**CITY OF ROCKVILLE PLANNING DIVISION
STAFF REPORT**

February 28, 2002

Exploratory Application for Planned
Residential Unit
PRU2001-00020

Proposal

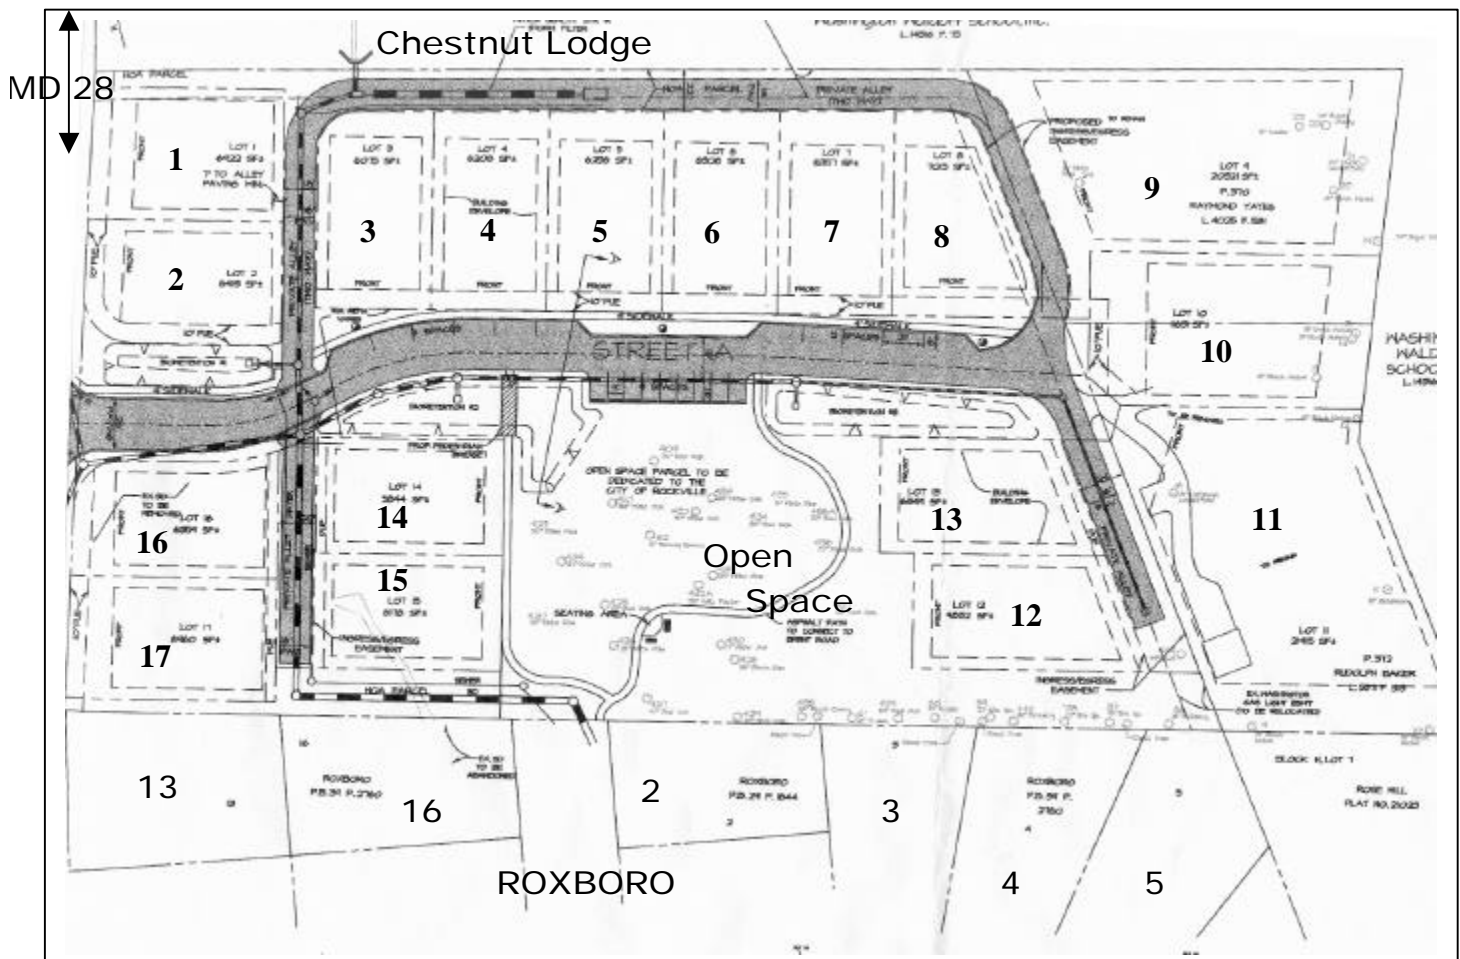
The Applicant is proposing to utilize the Planned Residential Unit special development procedure to create a 17-unit subdivision on the subject tract. Since the tract currently contains three homes, the net increase is 14 homes. The existing Baker and Yates homes will remain. The Buckingham home will be demolished and 15 new single-family detached houses will be constructed. Most of the houses will be centered around a $\pm .78$ acre proposed public park that will be dedicated to the City of Rockville in order to preserve a significant stand of specimen trees. It is worthy of note that the Applicant originally requested 16 new houses, but removed one lot in order to protect a larger stand of trees.

Alley 1, as shown on Exhibit A, will be a 16-foot wide two-way private alley that will provide rear-loaded garage access to nine of the properties on this site. The Homeowner's Association (HOA) will maintain this alley. Of the ten houses served by this alley, seven new houses will front on Street Two new houses served by Alley 1 will front on West Montgomery Avenue. Alley 1 will also serve the existing Yates property, which will have frontage on Street A. New Lot 10 will have Alley 1 pass in front of it, but will have access from a different private driveway. This alley will run parallel to the extreme eastern edge of the site. There will be a five-foot wide HOA parcel adjacent to the alley and the property boundary that will provide landscaping and decorative fencing.

Alley 2 on Exhibit A will serve two new homes. It will also be a private alley maintained by the HOA. The two lots served by this alley will front on the previously referenced open space parcel. The existing Baker property will be served by a driveway that will connect to Street A. Lot 10 will have driveway access from here as well.

Alley 3, as shown on Exhibit A, will serve four new houses. Two of these houses will front on West Montgomery Avenue, and two will front on the proposed park.

1. Submission, for approval by the Chief of Planning, of eleven (11) copies of the site plan, revised according to Planning Commission Exhibit A, to show the following:
 - a. The development standards be modified as follows:

1. Minimum Rear Yard Setbacks:
 - a. 7 feet to the edge of alley paving for garage (attached or detached).
 - b. 18 feet to structure of house,
 - c. Lots 6, 7, 8, 12 and 13 only: 18 feet to the edge of alley paving for house and garage. This provision applies to attached or detached garages.
